HARDWARE PATCH for Zemmix Neo, SX-1, SM-X and related machines (update 2020.04.06)

2020.08.19 Hardware Patch for OCM machines “aka BUSDIR_n patch”

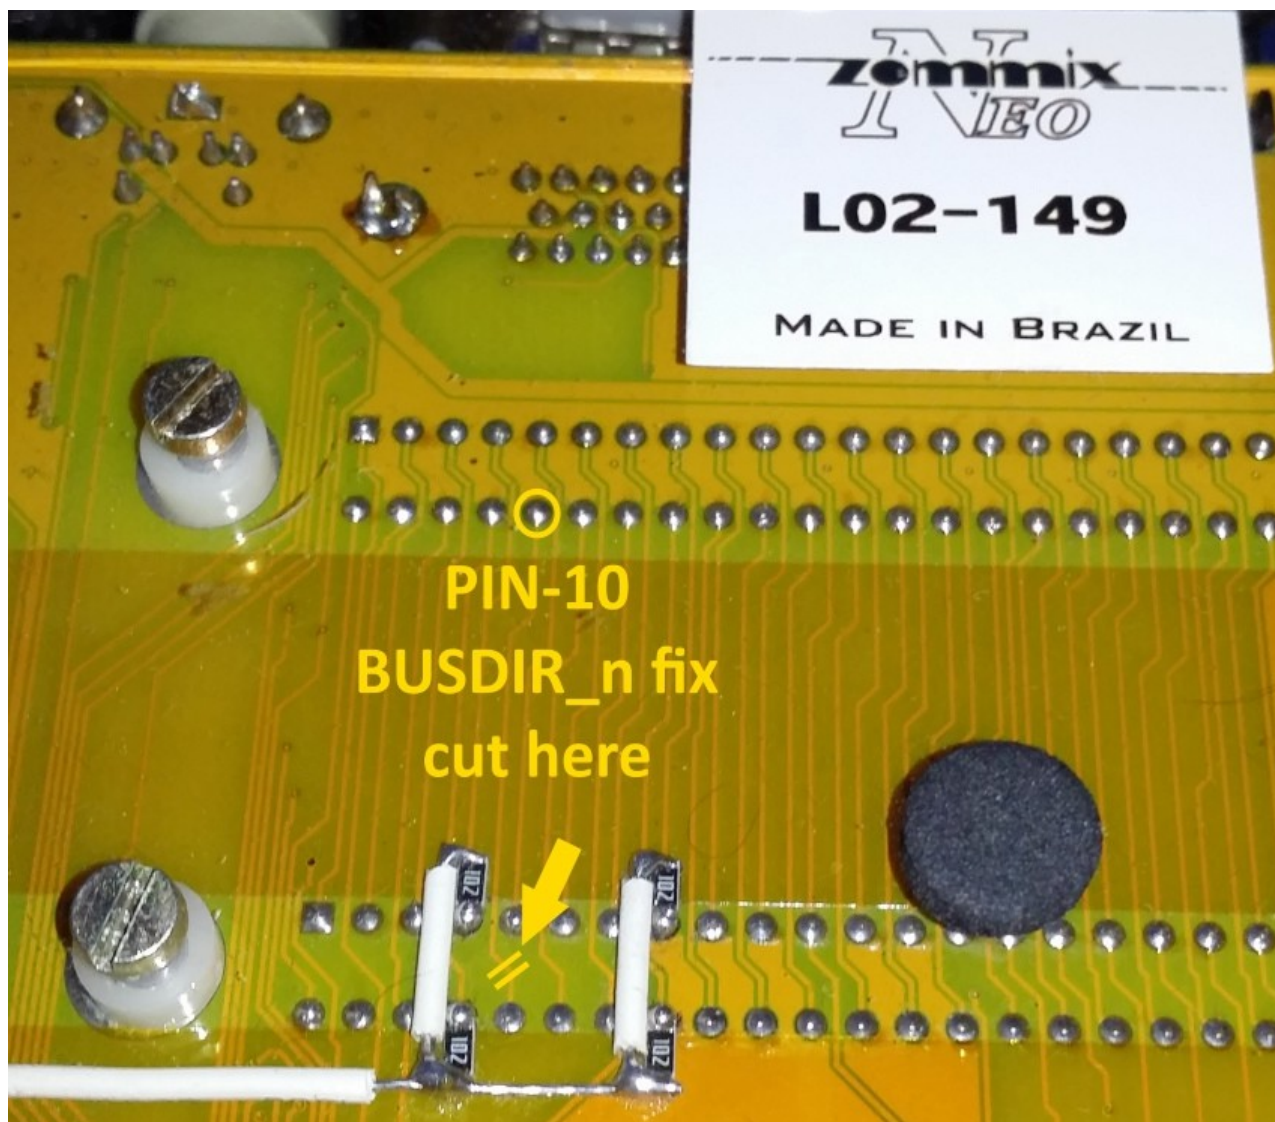
- In OCM machines we have a short circuit between pin-10 (BUSDIR_n) of the two external slots that continues towards the FPGA. This type of connection confuses some cartridges.
- While the Panasonic FS-A1ST and Canon V-20 service manuals confirmed that the BUSDIR signal is not used.

- Pin-10 (BUSDIR_n) of the external slots must be isolated.

- Method 1 - Cut the track that connects pin-10 of Slot-1 and Slot-2 leaving unchanged the connection to the FPGA already internally isolated by the firmware.
- Method 2 - Desolder pin-10 of slot-2 from the PCB and insulate it with the sheath of an electric wire and a drop of hot glue.
- Method 3 - Place non conducting tape over pin 10 of those cartridges that are not working properly, such as MoonSound and Darky.

2020.10.16 Hardware patch for Zemmix Neo BR machines (aka +5V line stability fix)

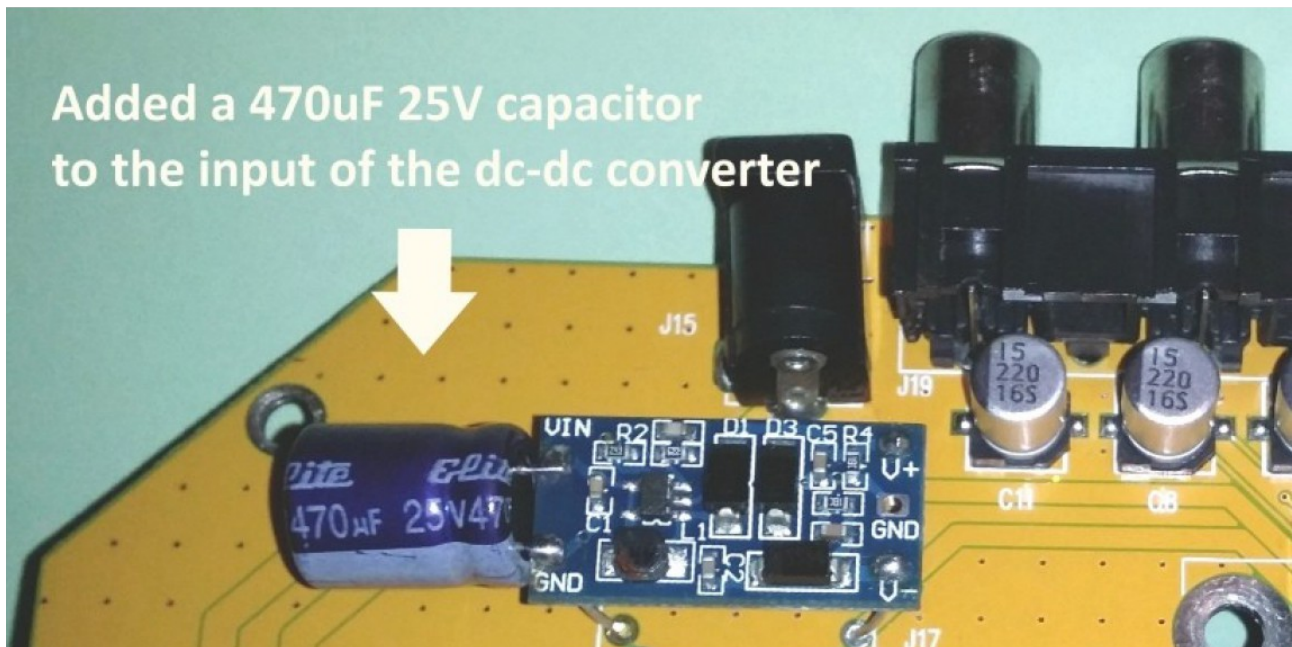
Based on the wiring diagram of the original 1chipMSX machine, I have implemented this new hardware patch for Zemmix Neo Brazilian which allows to stabilize the +5V input line. This patch can for example remove some annoying video interference on the output of GFX9000 and other similar cartridges. Please be informed that the problem is currently only present on Zemmix Neo Brazilian and not with Zemmix Neo Korean, but this fix can still be used if your hardware is unstable.

2022.04.19 Hardware Patch for SM-X, SX-2 and related machines (aka PS/2 keyboard compatibility fix)

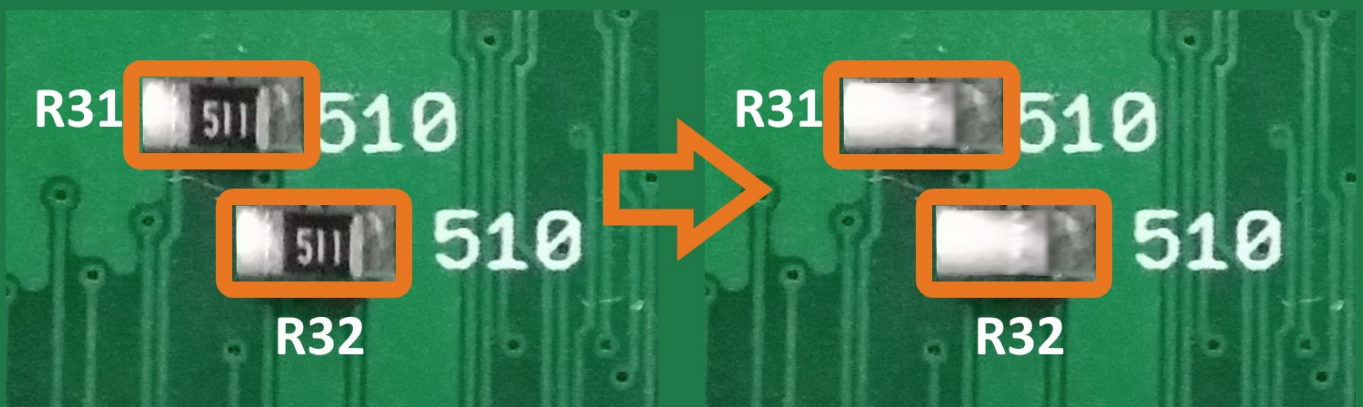
How to do it: short-circuit R31 and R32 like in this photo.
